Service information

Reference no.: GDA_96174

Internal water and steam circuit changed

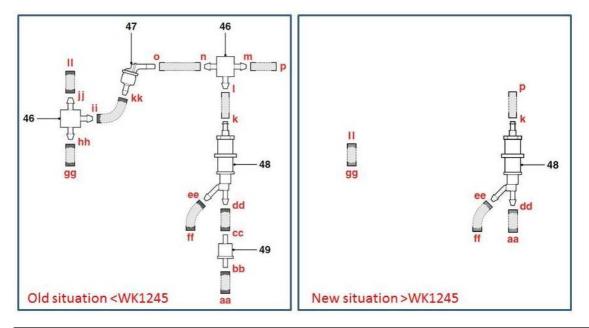
INFO: From WK1245 onwards the water and steam circuit in Senseo Latte and Cappuccino Select applainces has changed. To reduce the complexity of the system some parts have been excluded, not affecting the performance of the appliance. in the new situation the appliance will not vent the steam system into the water comtainer, the bypass valve (Pos. 44 in SLS, Pos. 48 in SCS) will connect directly to the valve outlet, next to the 3-way valve.

Senseo Latte Select removed:	Senseo Cappuccino Select removed:
Pos. 42 T-piece (2x) Pos. 43 Venting valve Pos. 43 Venting valve Pos. 65 Pos. 90 Pos. 93 Valve Pos. 90 Pos. 93 Valve Pos. 90 Pos. 93 Valve Pos. 90 Pos. 94 Pos. 9	Pos. 46 T-piece (2x) Pos. 47 Venting valve Pos. 47 Venting valve vsituation, as variables have been changed in length and position to assure
